11 SUB2010-00065

HAMPTON PARK SUBDIVISION

DETAIL SITE PLAN

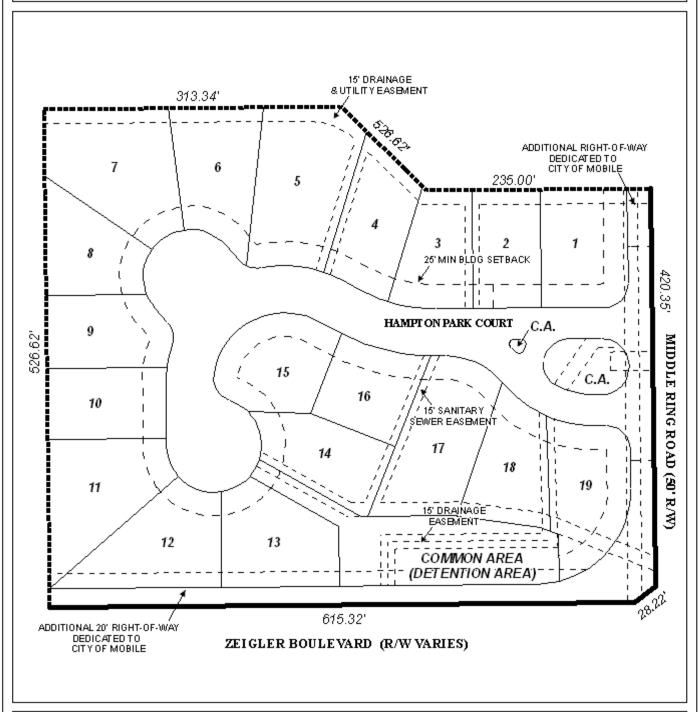
The site fronts Zeigler Boulevard and Middle Ring Road, both of which are planned major streets, and as such require 100-foot rights-of-way. As shown on the preliminary plat, the final plat should show the existing rights-of-way, and dedication of sufficient right-of-way to provide 50 feet from the centerlines of Zeigler Boulevard and Middle Ring Road (excluding service roads). Furthermore, direct access to Zeigler Boulevard and Middle Ring Road should be denied for Lots 1, 11, 12, 13, and 19. Each lot should be limited to one curb-cut, with the size, design and location to be approved by Traffic Engineering, and to conform with AASHTO standards.

As previously mentioned, streets for the development have been constructed. The most recent approval by the Planning Commission included a waiver of Sections V.B.14. and V.B.15. (culde-sac ROW and pavement widths) of the Subdivision Regulations due to the fact that the culde-sac design could not be modified to meet the 120 foot diameter requirement: such a waiver would once again be appropriate with this application.

The plat shows common and detention areas, and the required note assigning responsibility for their maintenance to the property owners. In addition, the plat depicts access to the common detention area from the subdivision streets, rather than from Zeigler Boulevard or Middle Ring Road.

It appears that all lots will meet the minimum size requirements of the Subdivision Regulations, however, the size of the lots in square feet are not indicated. The plat should be revised to label each lot with its size in square feet, or a table with the same information should be placed on the final plat, if approved.

Based upon the preceding, and with a waiver of Sections V.B.14. and V.B.15. (cul-de-sac ROW and pavement widths) of the Subdivision Regulations, the application is recommended for Tentative Approval, subject to the following conditions:

- 1) compliance with Engineering comments (Subdivision construction complete, ready to be accepted for maintenance);
- 2) dedication of sufficient right-of-way to provide 50 feet from the centerlines of Zeigler Boulevard and Middle Ring Road, as shown on the preliminary plat;

- 3) acceptance of the new streets by City Engineering;
- 4) placement of a note on the final plat stating that direct access to Zeigler Boulevard and Middle Ring Road is denied to Lots 1, 11, 12, 13, and 19, as shown on the preliminary plat;

- 5) placement of a note on the final plat stating that each lot is limited to one curb-cut each, with the size, design and location to be approved by Traffic Engineering, and to conform with AASHTO standards;

- 6) placement of a note on the final plat stating that maintenance of common areas will be property owners' responsibility;
- 7) label of each lot with its size in square feet, or placement of a table on the plat with the same information; and

- 8) placement of a note on the final plat stating that approval of all applicable Federal, state and local agencies for endangered, threatened or otherwise protected species is required prior to the issuance of any permits or land disturbance activities.
